Approved Section 4.55 (.....2.....) Modification Application

Project
BARANGAROO STAGE 1B
PUBLIC DOMAIN
Modification S4.55

Drawing Title
**HICKSON PARK WEST ENTRY
DETAIL PLAN - NO TREES**
Drawn
SS

Sheet No27..... of55.....

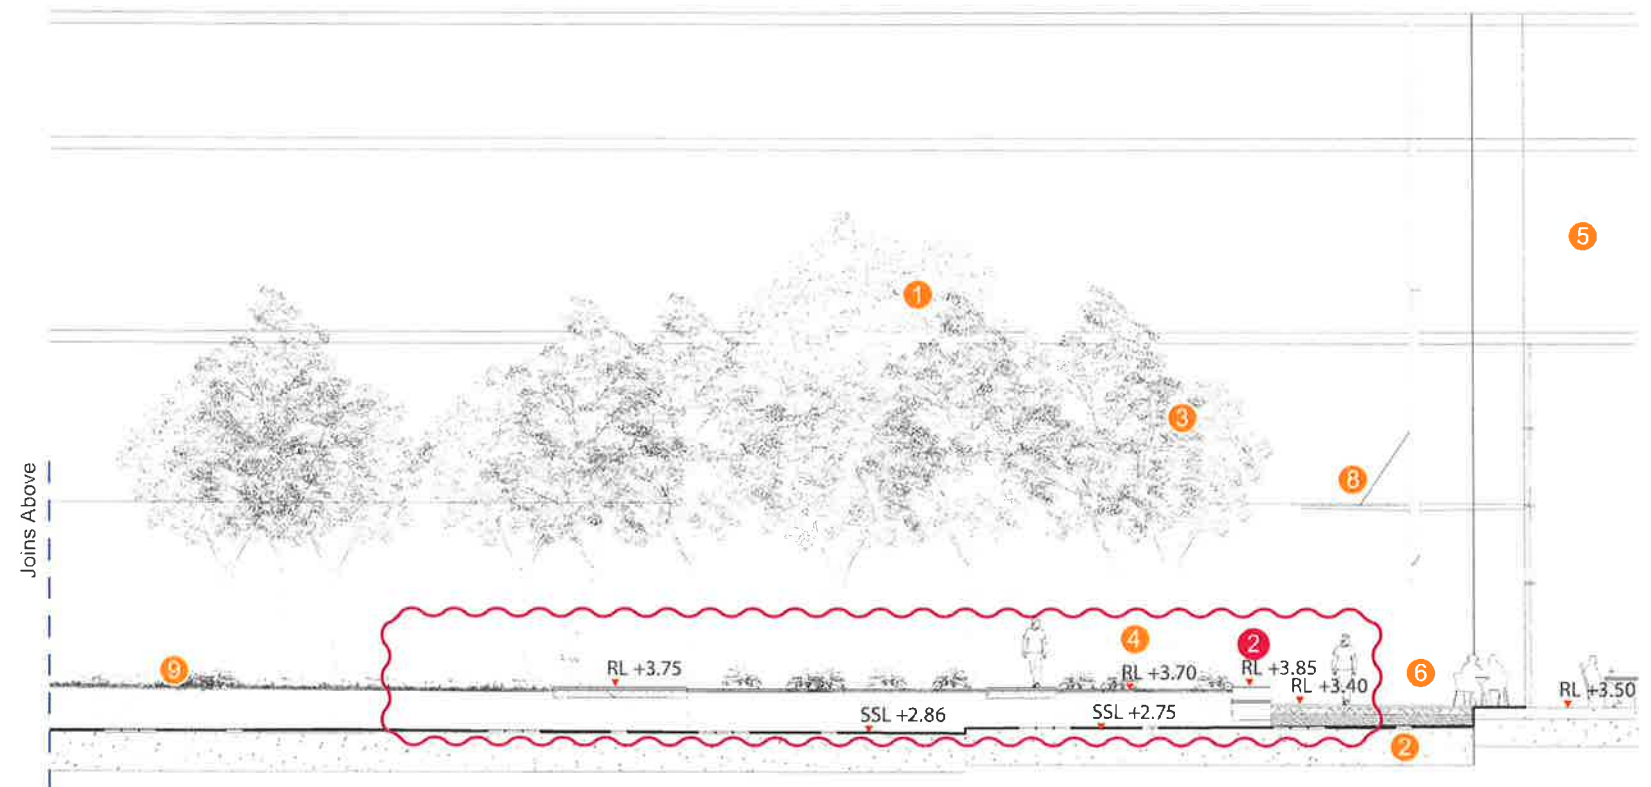
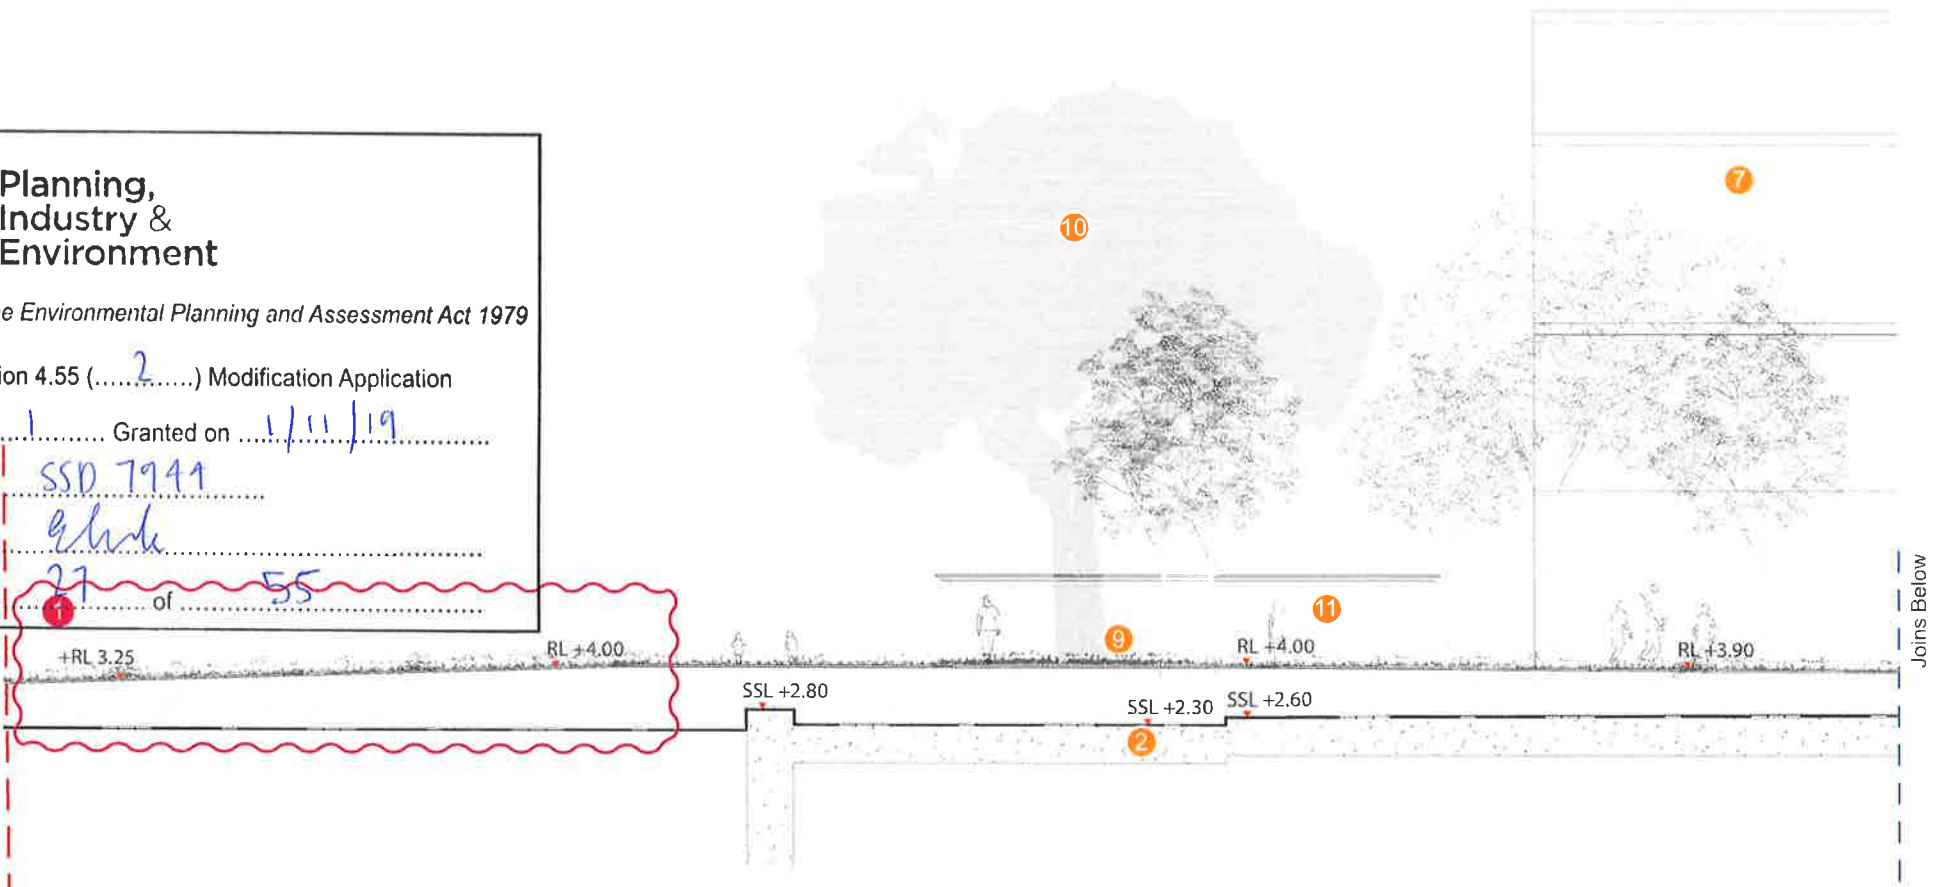
- Proposed Modifications**
-  Amendment cloud
 - 1 Levels changed due to proposed Hickson Road levels
 - 2 Increase planting area within the park, change of geometry and remove 1no. access stairs.

Sheet No 29 of 55

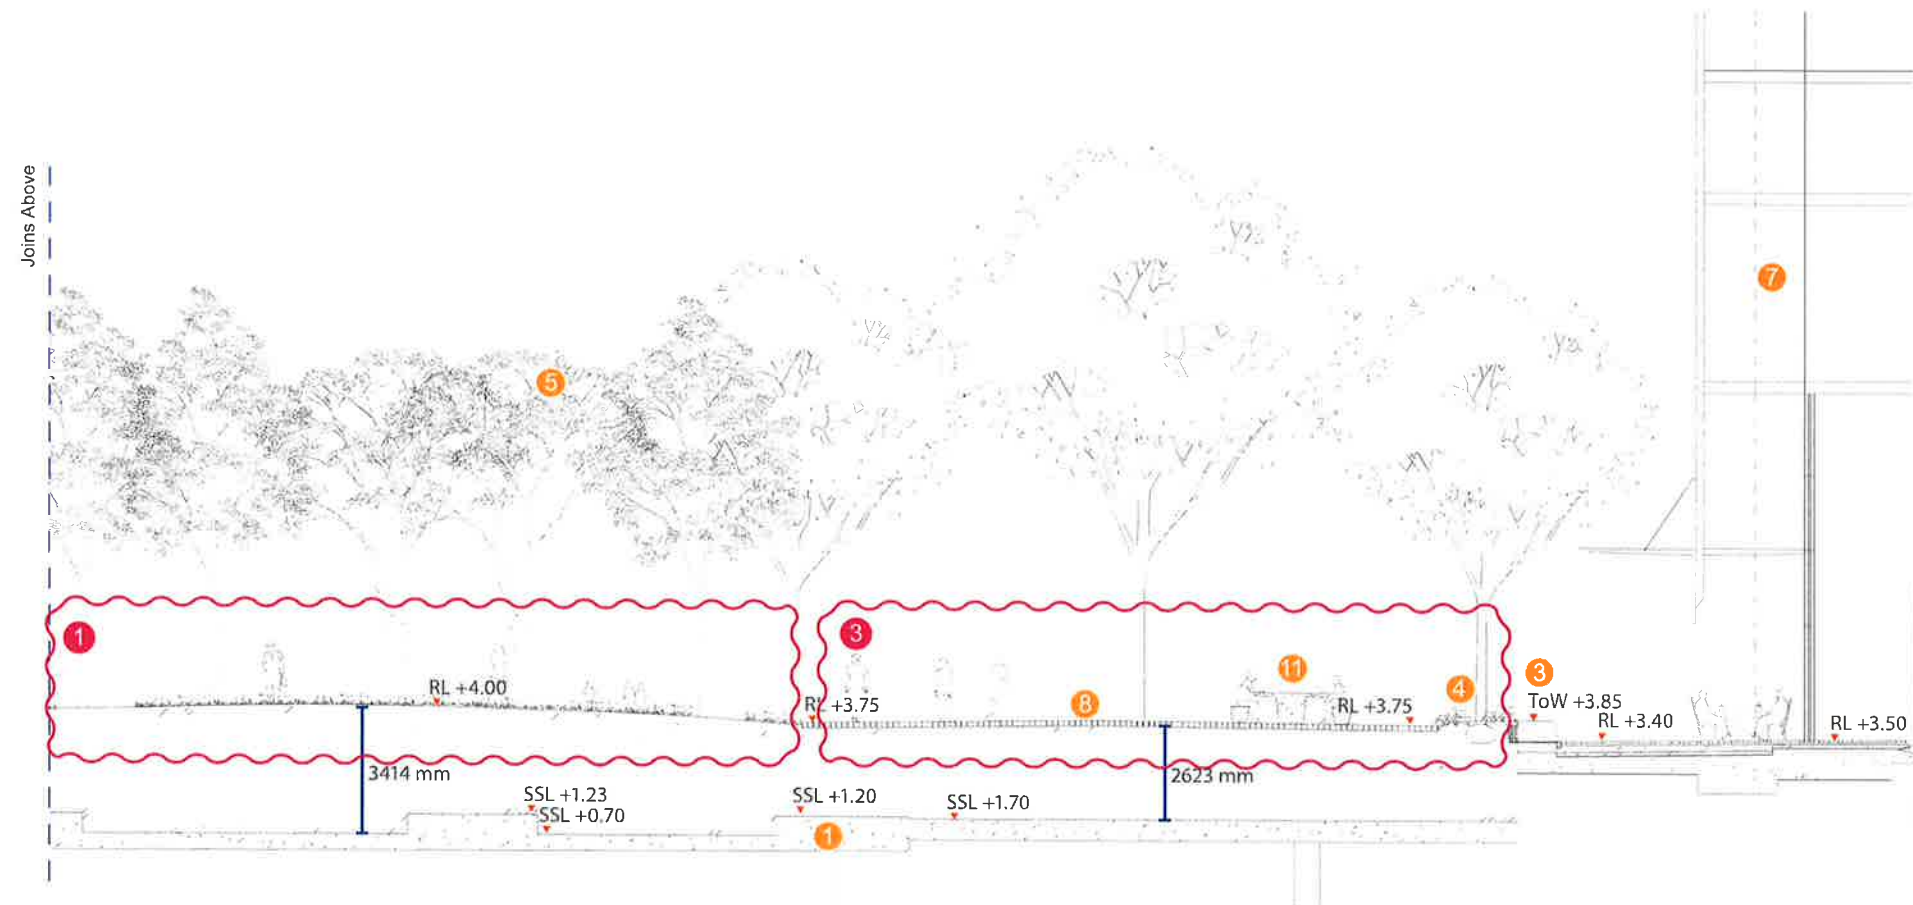
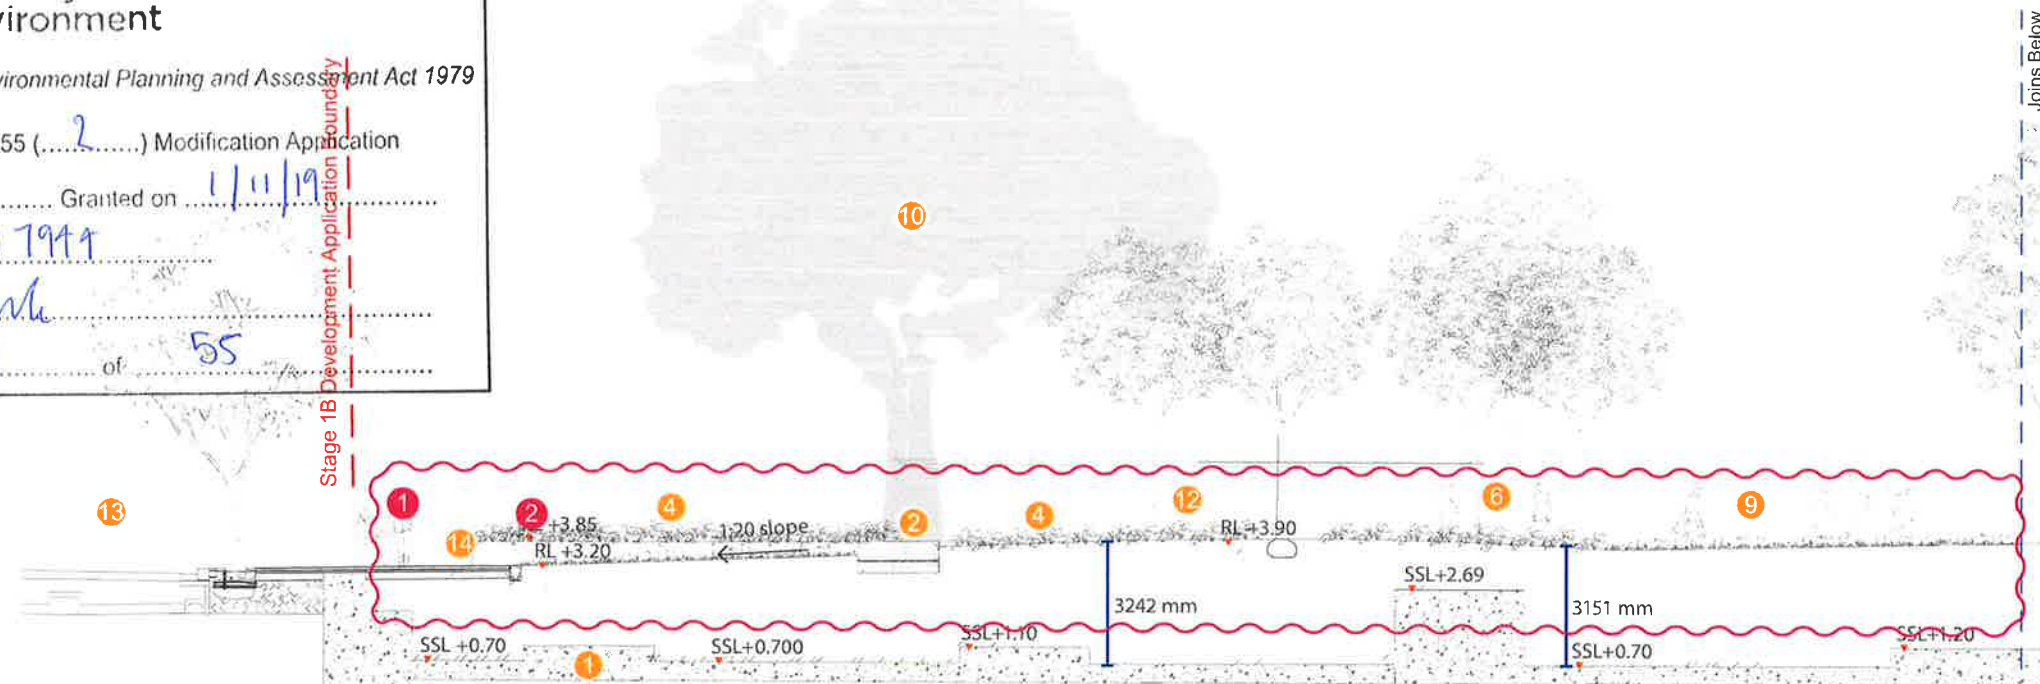
- Amendment cloud
- 1 Levels changed due to proposed Hickson Road levels
- 2 Delete bollards to East park edge
- 3 Increase planting area within the park and change of geometry.

Sheet No 30 of 55

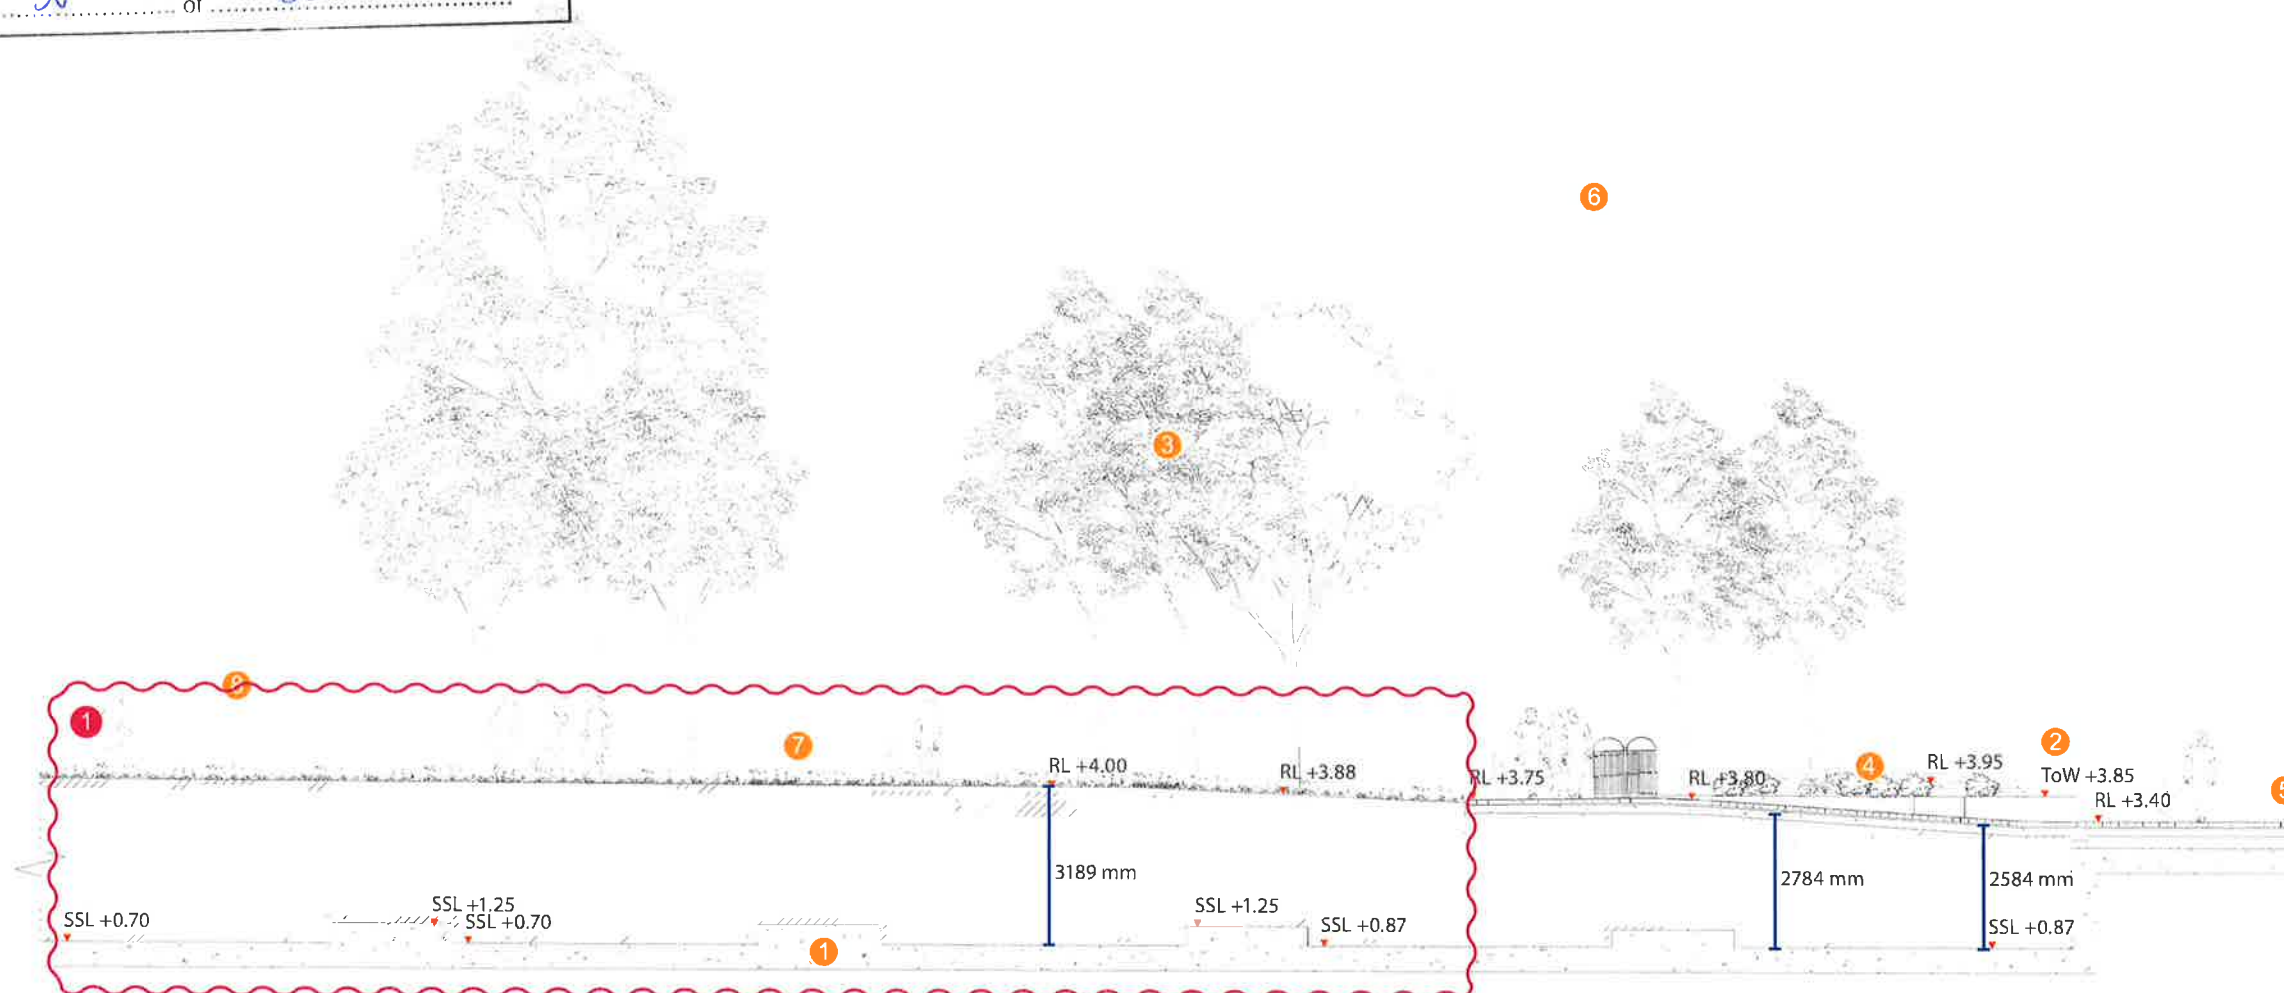
- 1 Levels changed due to proposed Hickson Road levels

Drawing Title
HICKSON PARK SECTION
I-I

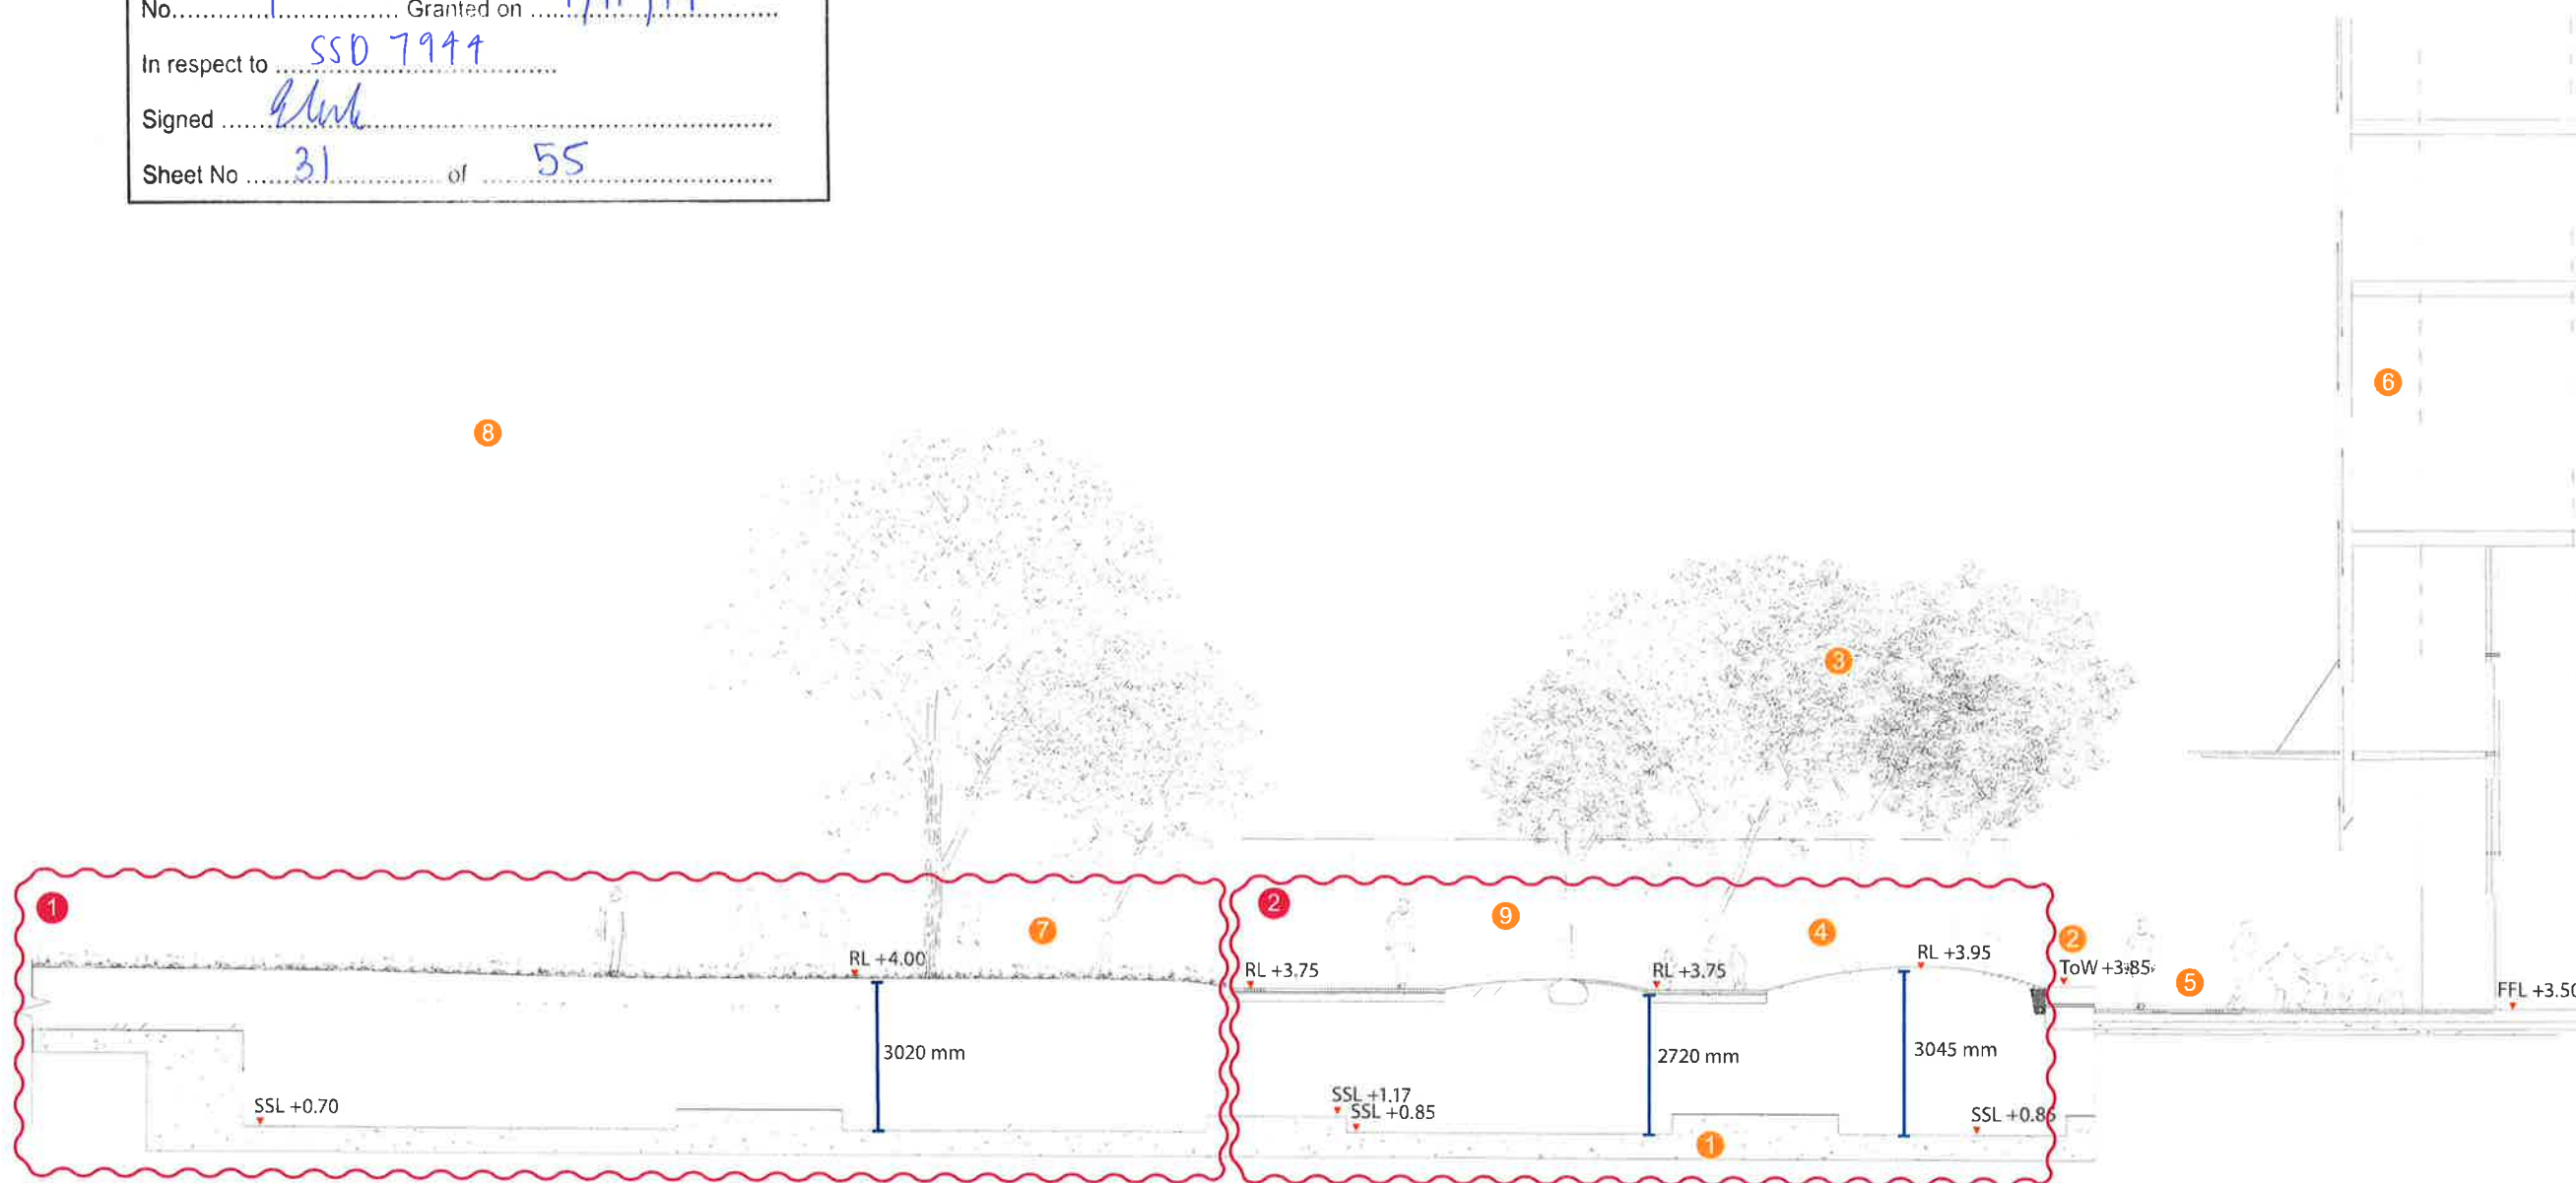
- 1 Levels changed due to proposed Hickson Road levels
- 2 Increase planting area within the park and change of geometry.
